<b>DOCKETED</b>	
<b>Docket Number:</b>	23-OPT-01
<b>Project Title:</b>	Fountain Wind Project
<b>TN #:</b>	263382
<b>Document Title:</b>	County of Shasta Letter Comments - Attachment 4 Visual Impacts
<b>Description:</b>	County of Shasta Letter Comments - Attachment 4 Visual Impacts
<b>Filer:</b>	Kari Cameron
<b>Organization:</b>	County of Shasta
<b>Submitter Role:</b>	Public Agency
<b>Submission Date:</b>	5/27/2025 2:34:49 PM
<b>Docketed Date:</b>	5/27/2025

## MEMORANDUM

**Subject:** Evaluation of CEC's Staff Assessment for the Fountain Wind Energy Project – Visual Impacts

Additional KOP 1

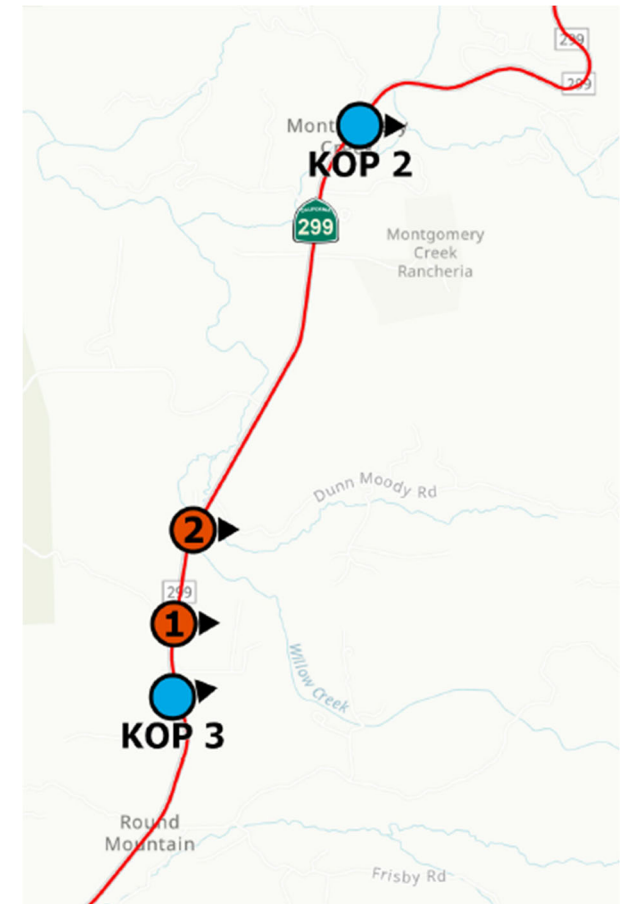
- Recommended KOPs 1 and 2 – These views were chosen to demonstrate the anticipated visual impacts of the proposed project combined with the cumulative impact of the Hatchet Ridge Wind Project in relation to the Round Mountain Substation and PG&E's 230 kV transmission facility.
- Recommended KOPs 3, 4 and 5 – Views 3, 4 and 5 were chosen for their clear view of the project site where travelers along State Route 299 can enjoy the scenic view of the natural landscape. Compared to the applicant's KOP 1, these photo locations also represent wider unobstructed views of the project site where visual impacts would be more frequently viewed for a longer duration along State Route 299.

**Figure 5.15-7**

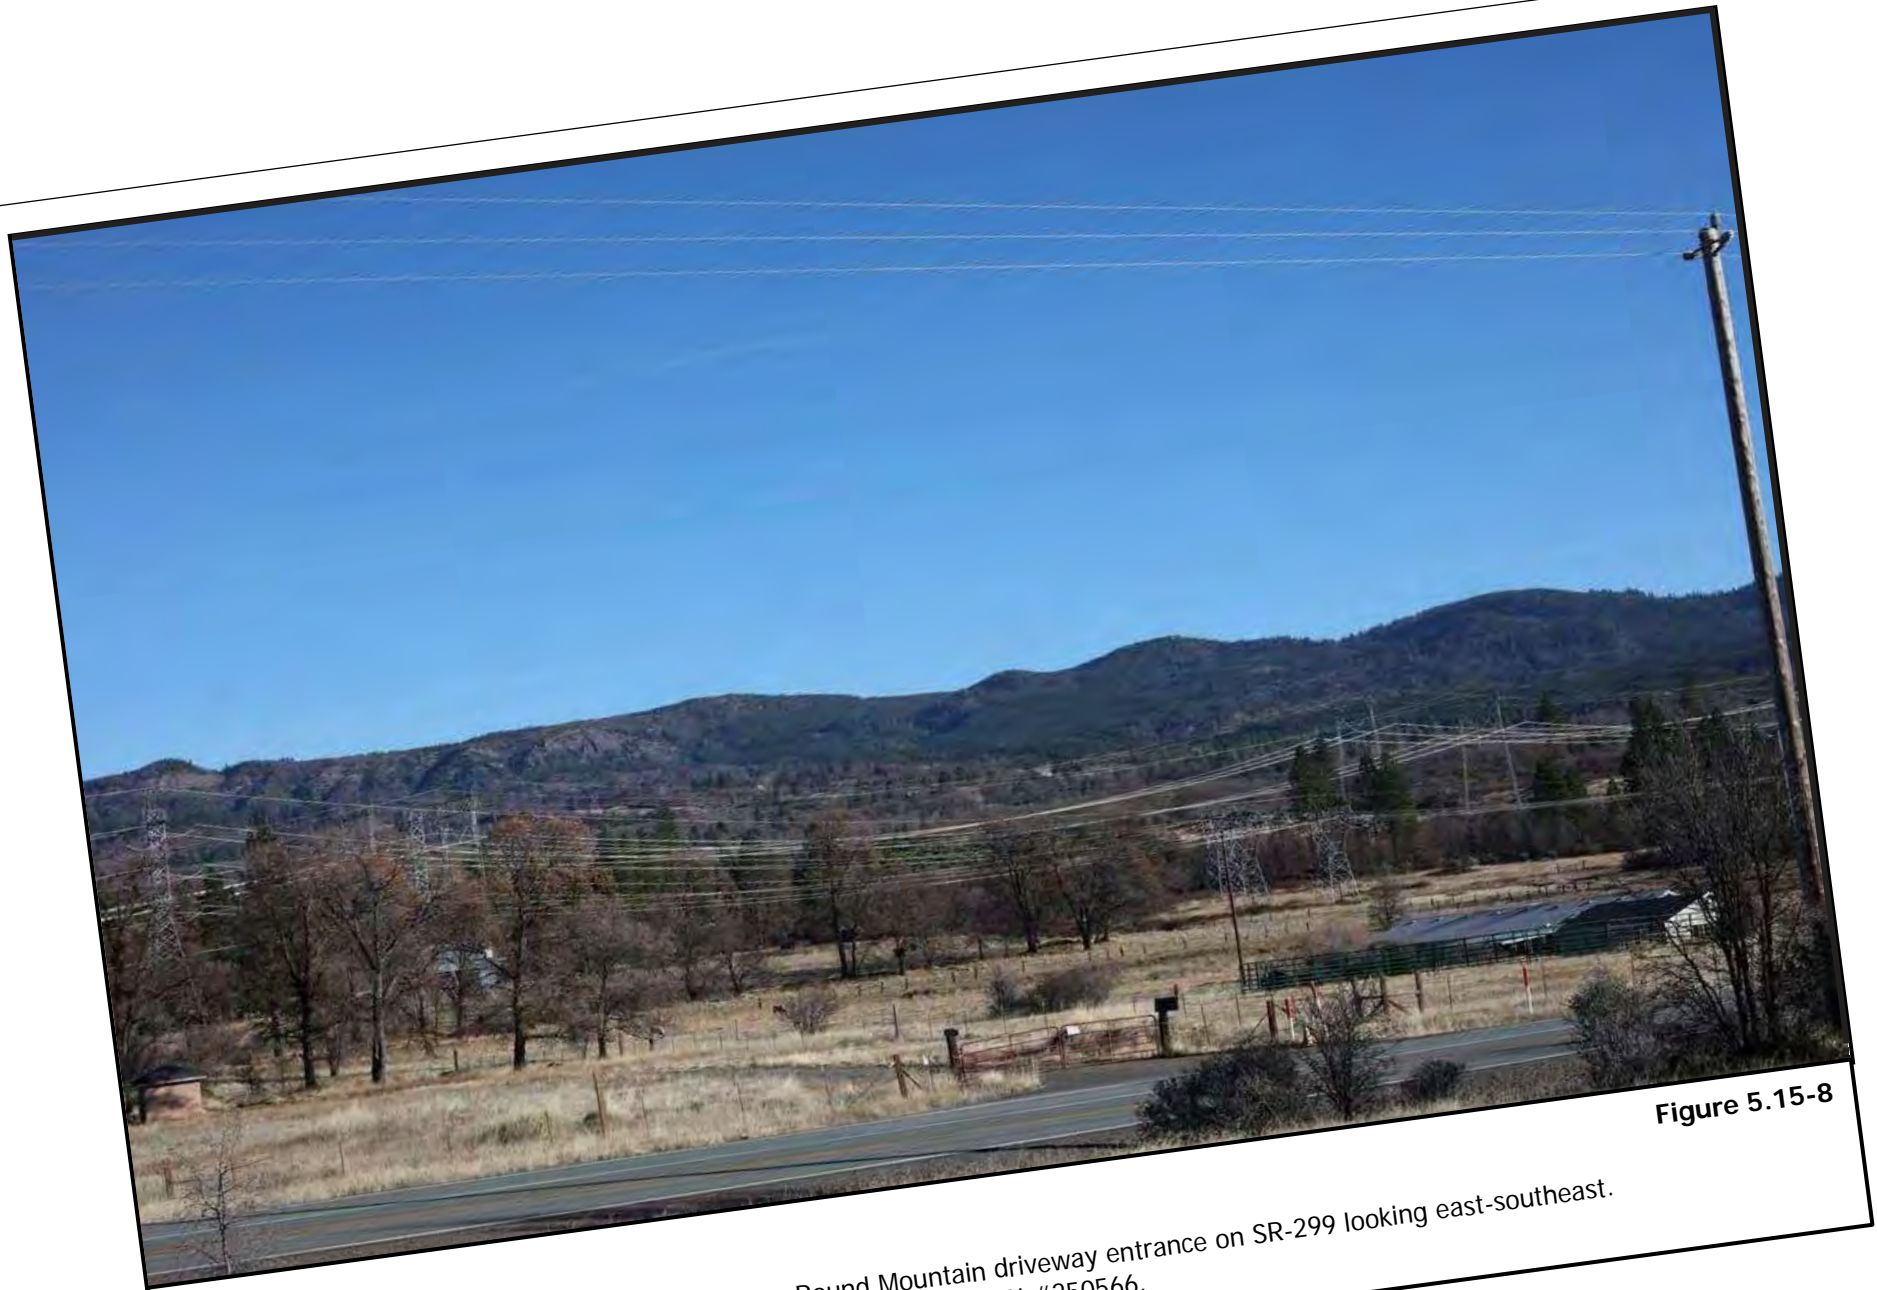
- KOP 1 and KOP 2: These views do not include agricultural, commercial, industrial, manufacturing or research and development land uses and only one single-family dwelling against a predominate backdrop of forested land rendering the EIR's Public View Rating of "low" as inadequate (see Table 5, EIR pg. 5.15-68). The views also include appreciated areas of cultural claim of significance in the region by the Pit River Tribe (see Visual Impacts to Tribal Cultural Resources subsection, below) and a *"view approaching an area of aesthetic, cultural, and recreation claim that may be closely related to the appreciation of the aesthetic, cultural, and recreation significance at that designation"* (see Public View Rating criteria, EIR pgs. 5.15-68; 80). Based on the above, the Public View Rating for KOP 1 and KOP 2 must be identified as "high" requiring the CEC to reassess the visual criteria utilized to determine the level of effect on the environment at these locations.

### NWCC Chart

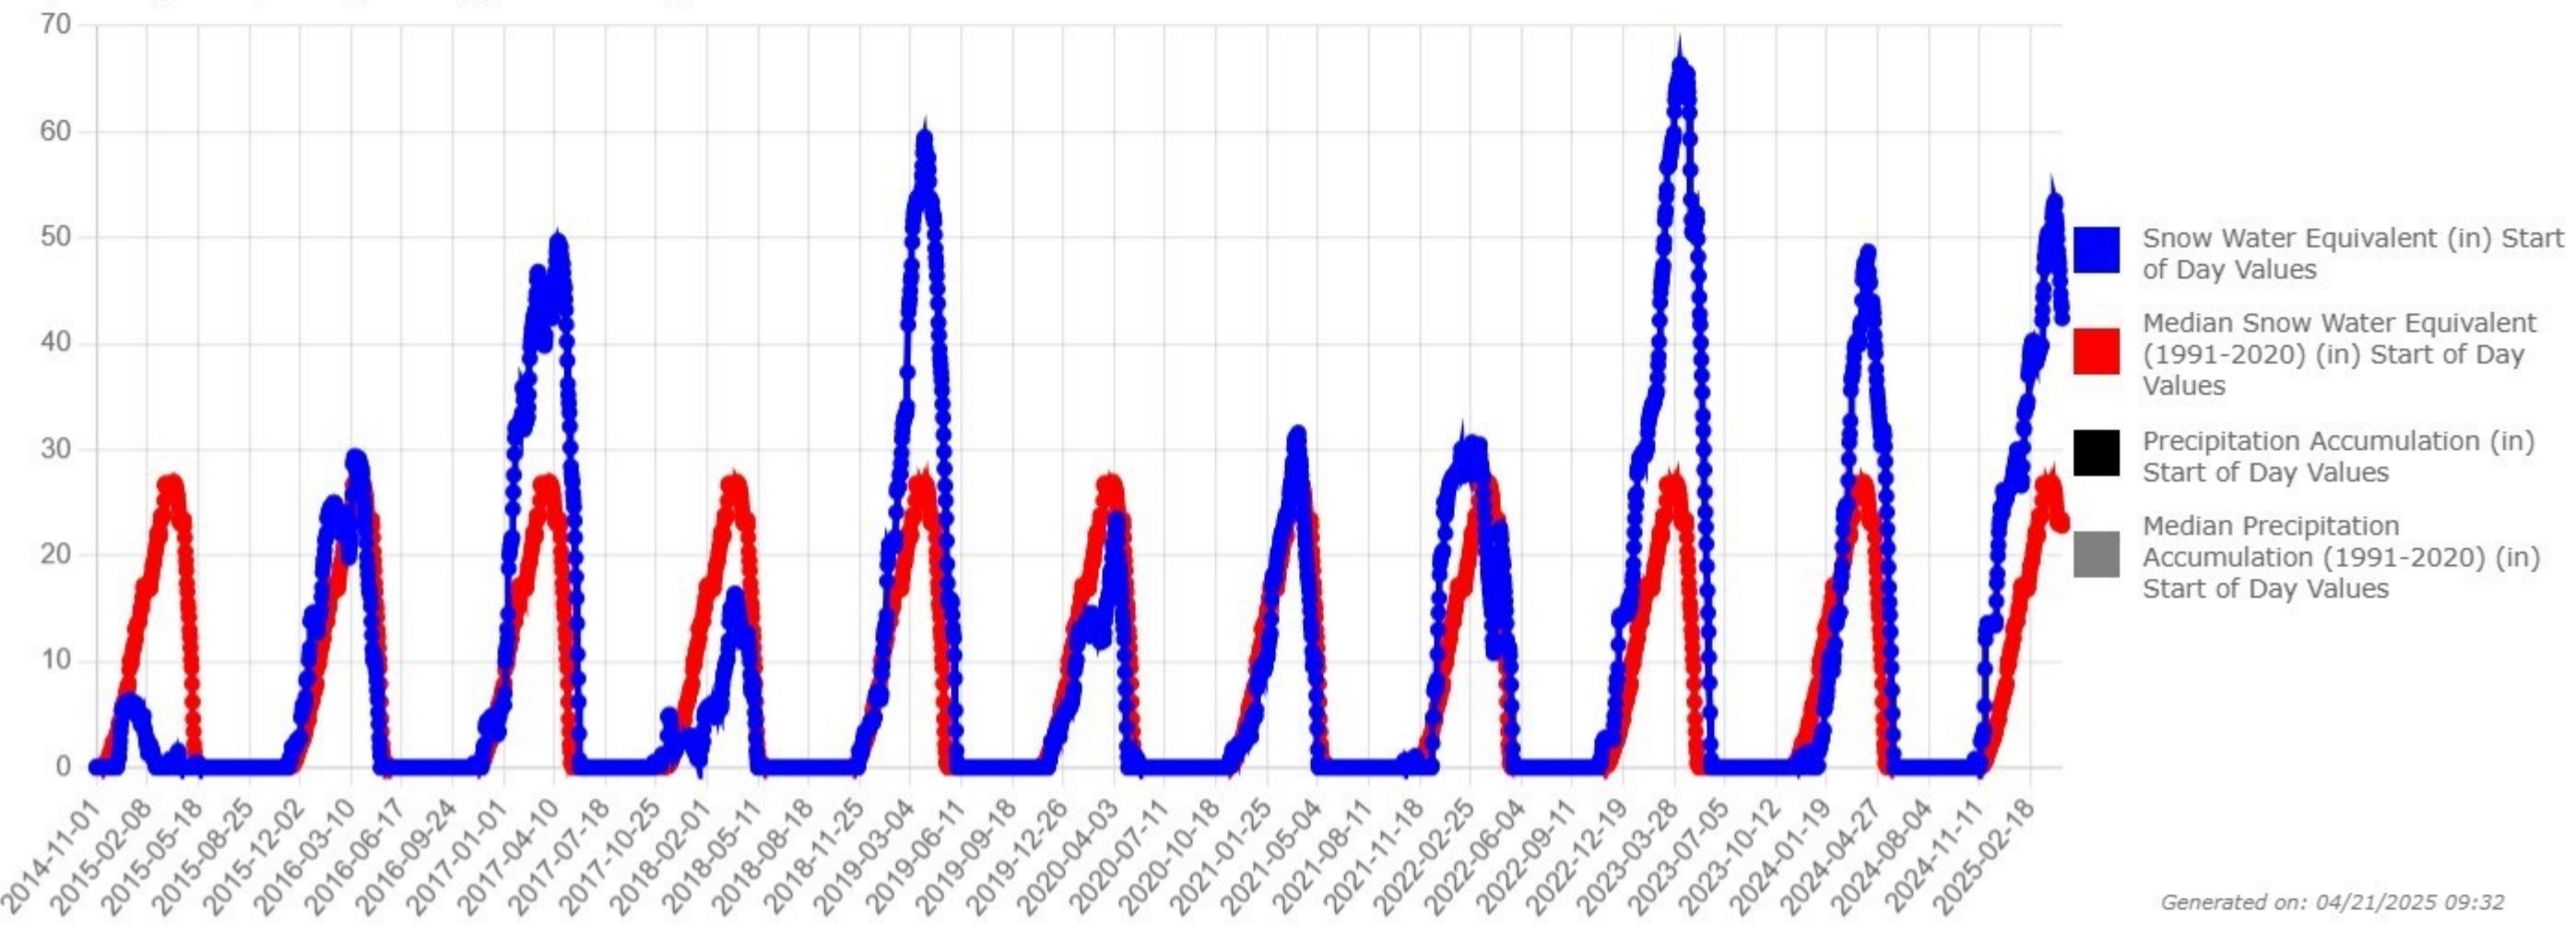
<sup>1</sup> During winter and spring months (October through May) between 2014 and 2025, snow water equivalent measurements at the Natural Resources Conservation Service (NRCS) Snow Mountain monitoring station report accumulated snow levels in the vicinity of the project ranging between 15 to 65 inches with a median accumulation of approximately 28 inches (see Attachment 3).
